## **Comments on Planning Application 24/2434/MOUT Land adjacent Furzehill Burnt Oak Sidbury**

### **Outline planning application for the erection of up to 43 residential dwellings**

#### **Introduction**

Figure 1 – Suggested realignment of Phase 1 to bypass Hillside

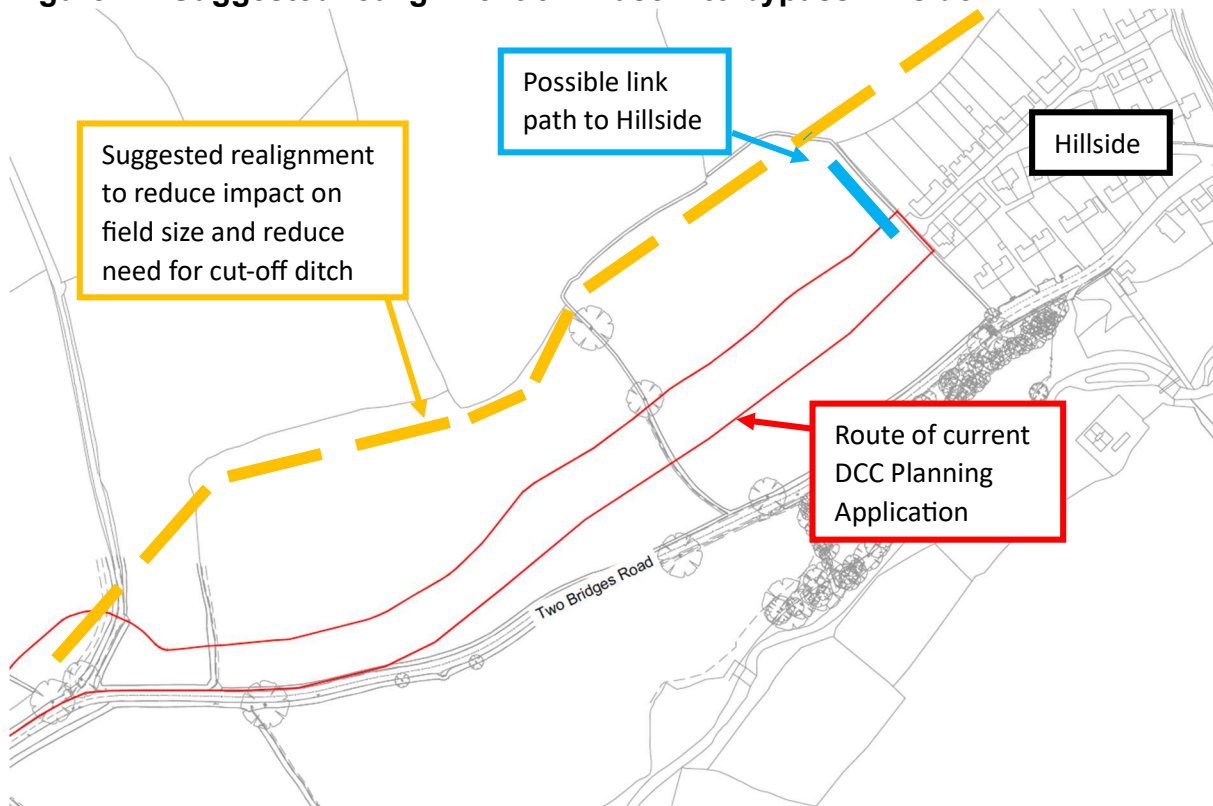
However, we note that this proposed connection from the development would require the path to climb an existing steep section of Ebdon Lane to connect to Phase 1 (See Figure 1 overleaf). The gradient of this section of Ebdon Lane is about 15% (1 in 7) which is considerably steeper than the absolute maximum gradient of 8% specified in LTN 1/20 (Local Transport Note on Cycle infrastructure design, Para 10.8.21).

We therefore suggest that the alignment of the path be altered as shown on Figure 1 to cross Ebdon Lane further west. This also has the advantage of providing access from the development to the proposed public open space as shown on the attached plan.

We note that a pedestrian access is proposed at the south-eastern corner of the site, adjacent to the existing electricity substation at the junction of Ebdon Lane with the A375. This will provide access from the site to the bus stops on the main road. We welcome the principle of a pedestrian connection at this location, but suggest this is moved further up Ebdon Lane as shown on Figure 1 above.

The survey plan shows a difference in height of about 1.5m from the development to Ebdon Lane along most of this boundary. Therefore, a connection to Ebdon Lane near the substation would probably require steps to accommodate this height difference. Bearing in mind the need to consider disabled access, a more practical location would be further west where there is scope to accommodate a ramp as shown on Figure 1.
